Valley View Short Plat/ LUA16-000272, SHPL-A, MOD

June 28, 2016, 11:00 AM

PROJECT NAME/NUMBER: Valley Vue Short Plat / LUA16-000272, ECF, SHPL-A, MQD

Slope is the Same

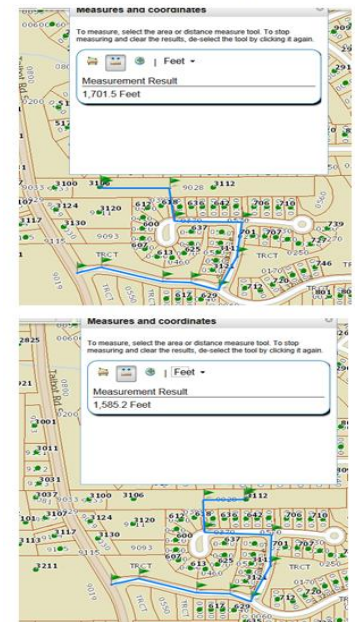
Winsper and the Talbot access to Lot 28 have the same 15% slope. This access has been used since 1947, and is the established access with a street sign saying “Private Road 3106, 3112 and 3120”. The 175 foot easement should be improved to its full 12 foot capacity, and Lot 28 with the Fire Code required 20 foot width and turn-around. Talbot Rd. is a collector arterial and should be the preferred access option.

(The Winsper Access had a 25% slope prior to improvement)

Fire Access Using Existing Talbot Private Road

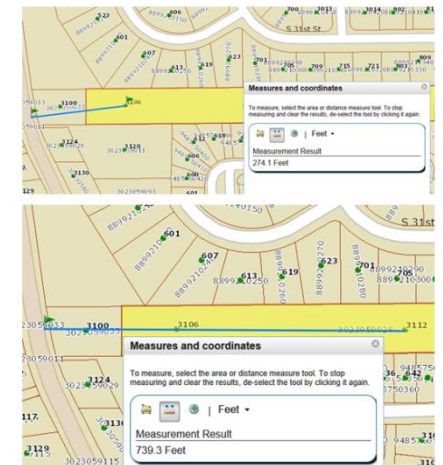
Talbot Access Direct Route for First Responders

The existing private road (highlighted in red) is 274 feet to 3106 Talbot, and 739 feet to 3112.

The Winsper access (highlighted in purple) is 1,702 feet to 3106 Talbot and 1,575 feet to 3112.

WINSPIER DIVISION I

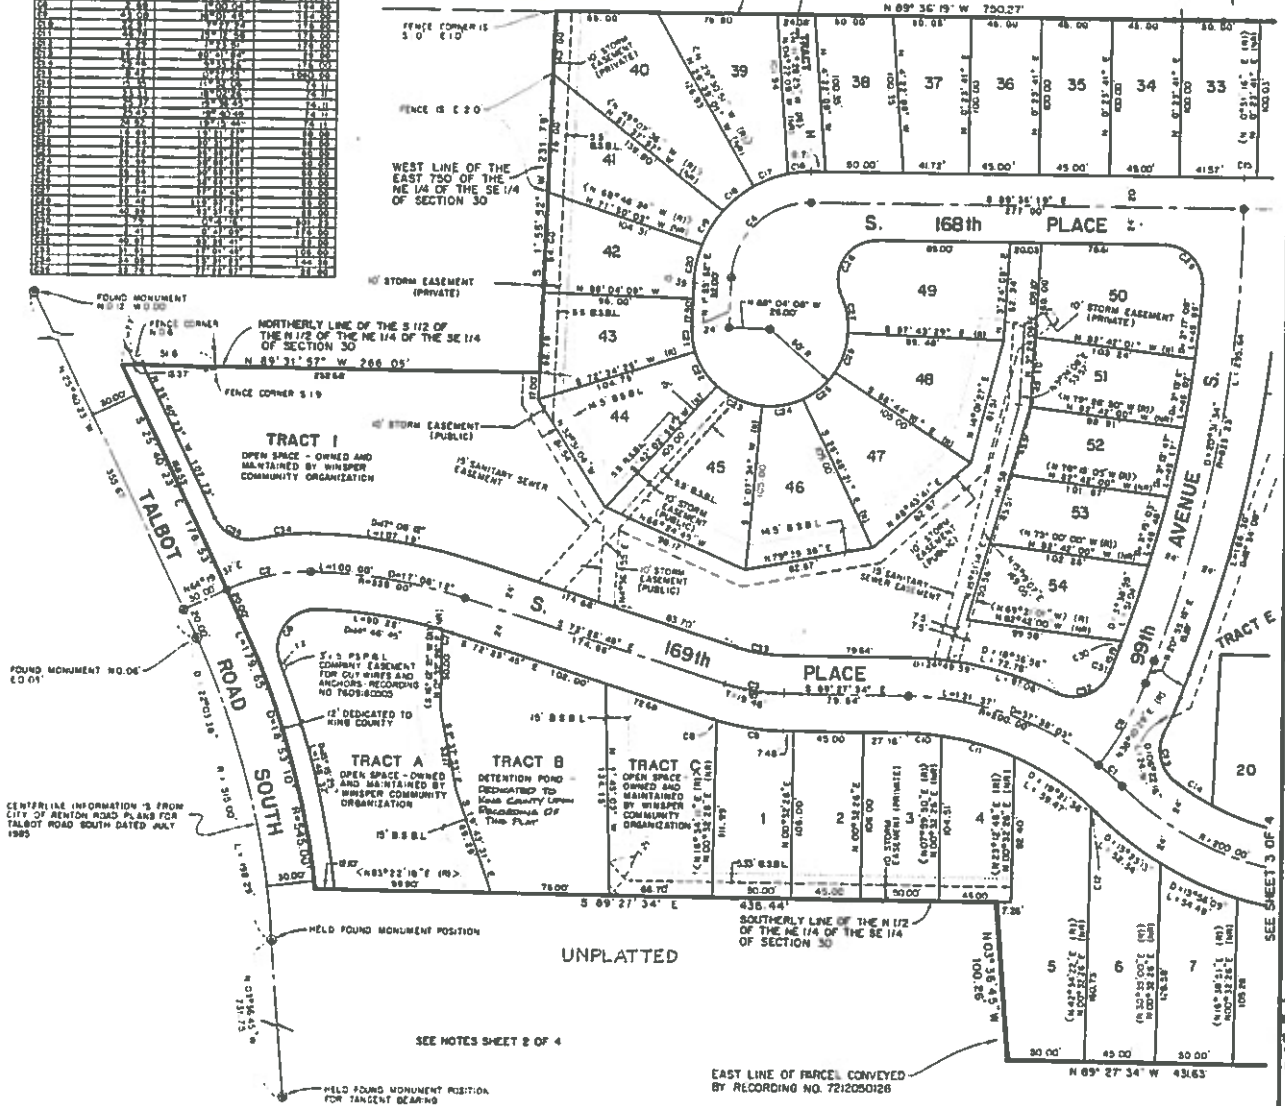
Tract H (future ingress/egress and utilities only) is owned by Winsper until "king county approves development of tax lot 28 which requires the use of this tract. This provision was written in 28 years ago. Development Codes have changed significantly since that time, the Governing Body, and the property owner have changed as well.

Disturbance Plan

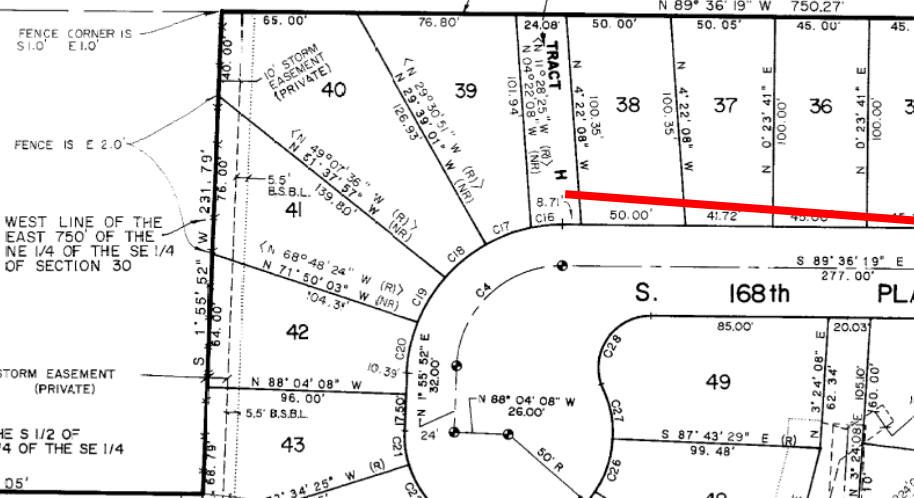
The disturbance limits (equipment maneuvering, grading, soil disruption) are shown to cross over the top of both the existing homes at 618 and 624 (it goes through the middle of my living room, it encroaches more than 16 feet into my driveway and backyard, and more than 10 feet into the neighboring property!) This is why it is so important to maintain the regulations which were put in place by the City to protect the public and assure reasonable development. Where are the access tract setbacks???

Encroaching beyond private property line

Existing Drainage,
Approximate

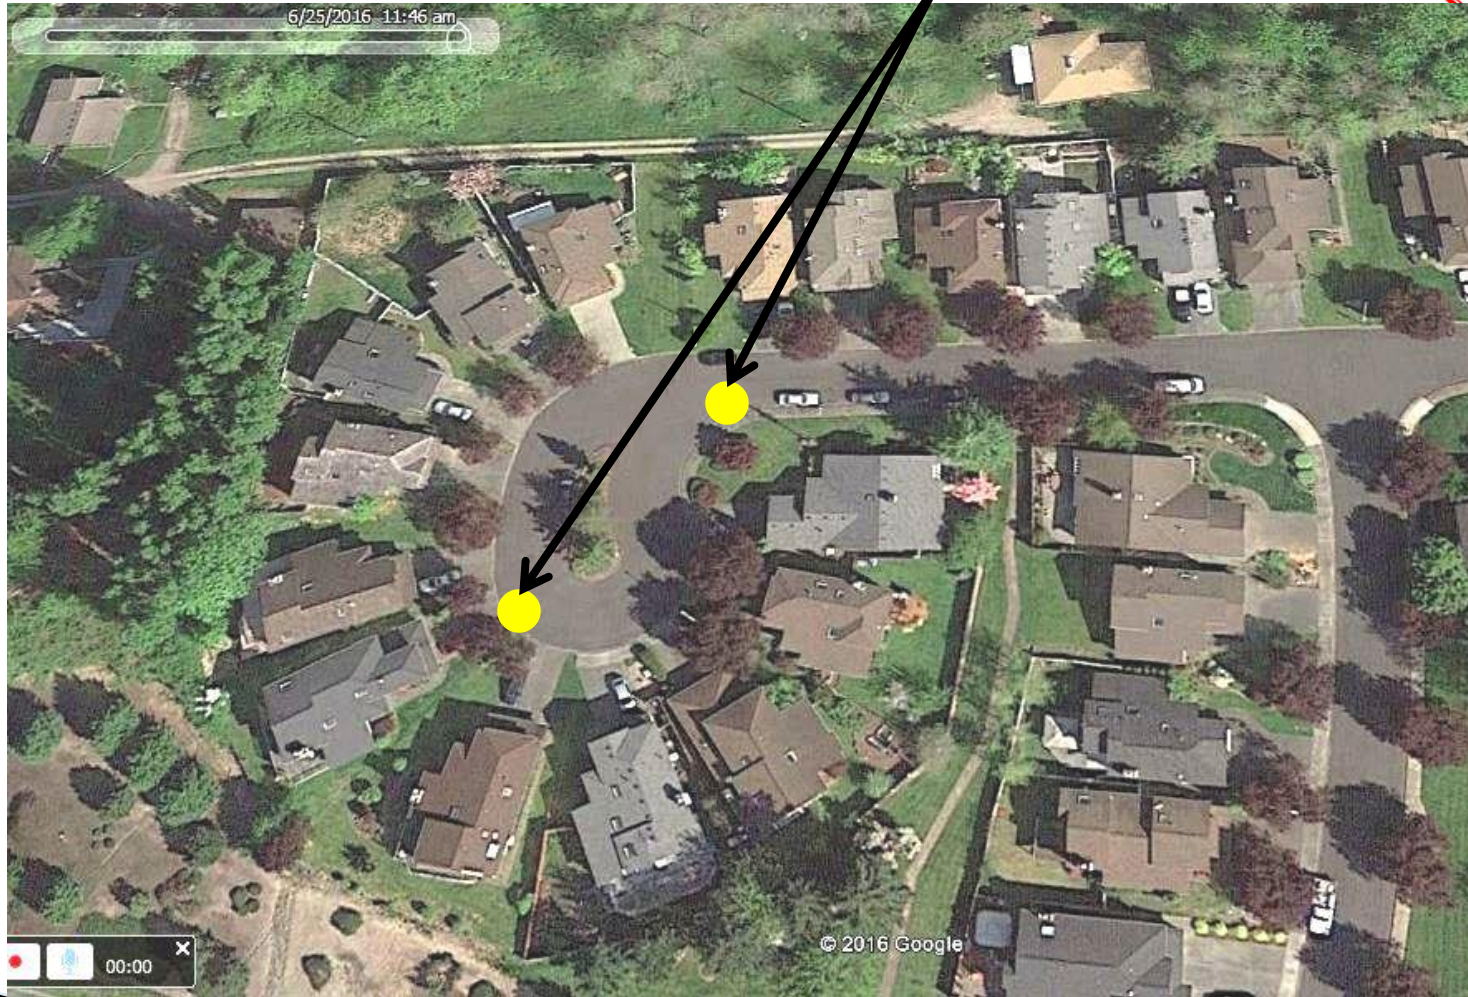
The driveway apron, which by definition begins at the curb and progresses up the driveway, cuts into the existing driveway at 618, bisecting the main water line, and sits on top of the water meter (3.5ft from the curb). It will destroy the drainage system I had to install after flooding under my house caused by run off from Lot 28.
